Project Name: Sheridan Street Apartments

Address: 152-156 SHERIDAN ST

The preliminary plans for the Sheridan Street Apartments have been reviewed by staff for conformance with the relevant review standards of the City of Portland's site plan ordinance. Staff comments are below.

Figures 6, 7, & 8: Existing site from 105 Washington Avenue (top left); as proposed with landscaping (top right); and proposed landscaping plan showing evergreen plantings at the northern, western, and southern property lines

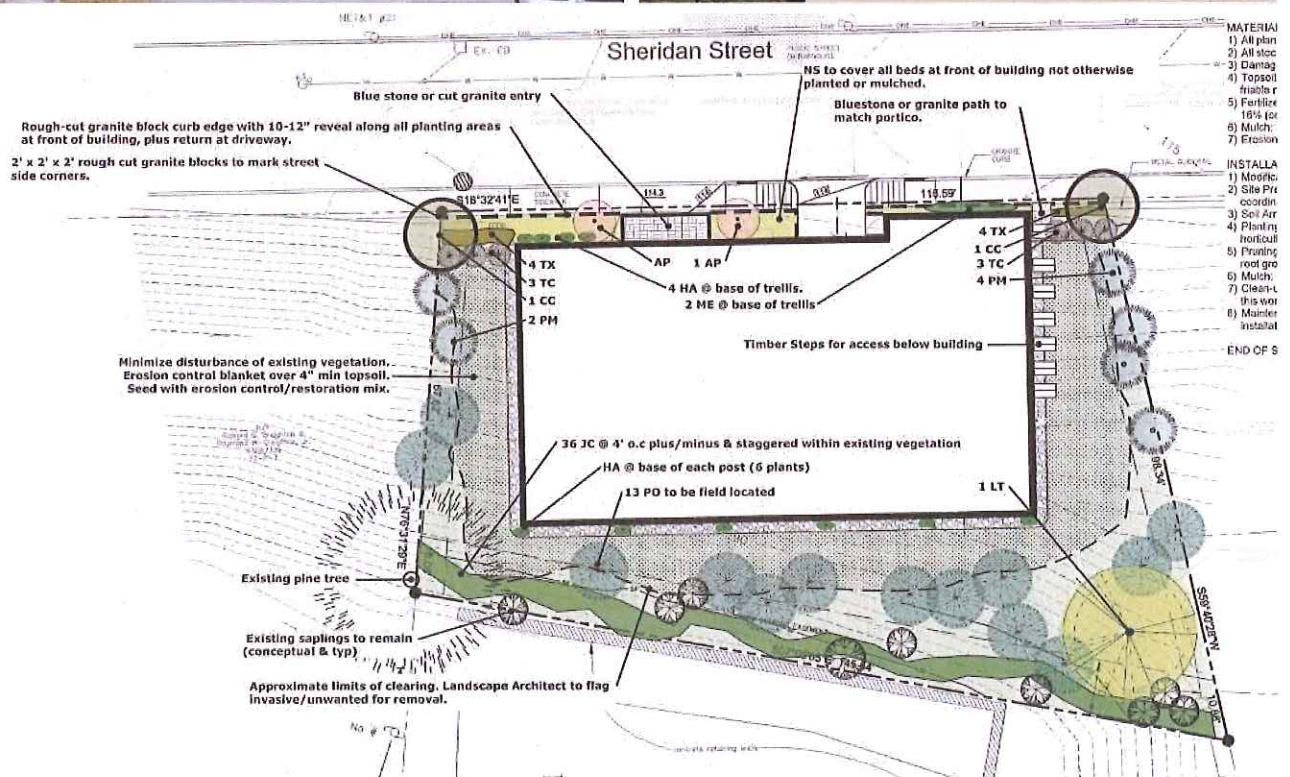
- b. *Landscaping and Landscape Preservation*
The applicant's landscaping plan shows a limit of clearing generally consistent with the setbacks and notes several existing trees to remain, particularly along the western property line (*Figure 8*). In terms of new plantings, the final landscaping plans showing climbing vines on the Sheridan Street façade, small ornamental trees to either side of the main entrance, and various evergreen plantings on the three other property lines.

The western property line is proposed with a number of Serbian spruce trees, a tree tulip, and juniper shrubs. Climbing hydrangeas are proposed on pier-supported trellises. The plantings are intended to screen the underside of the building during all seasons at full maturity. A view from Washington Avenue is shown in *Figure 7*.

The final renderings continue to show the building as a pier-supported structure, with a large open space beneath (*Figure 7 and Plan 24*). As noted in staff’s prior memo to the Board, this area could generate potential security concerns. The city’s site plan standards incorporate principles related to Crime Prevention Through Environmental Design (CPTED) and state that spaces should be designed to encourage “natural surveillance that promotes visibility of public spaces and areas,” “access control that promotes authorized and/or appropriate access to the site,” and “territorial reinforcement that promotes a sense of ownership and responsibility through environmental design” (*Section 14-526(c)2.a*).

Alex/Caitlin 11/2/13

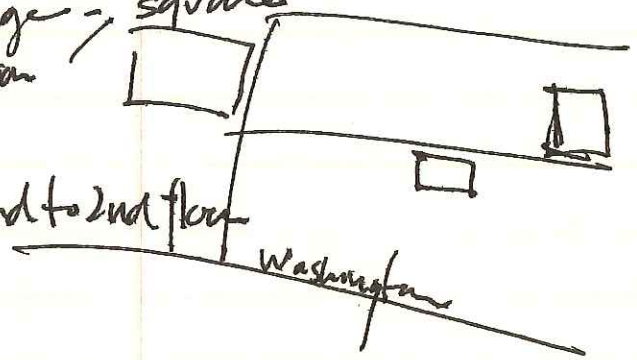
- screening on rear. - fence + landscaping. - take pics - compare

- railing safety. - no X.

- window variety ??
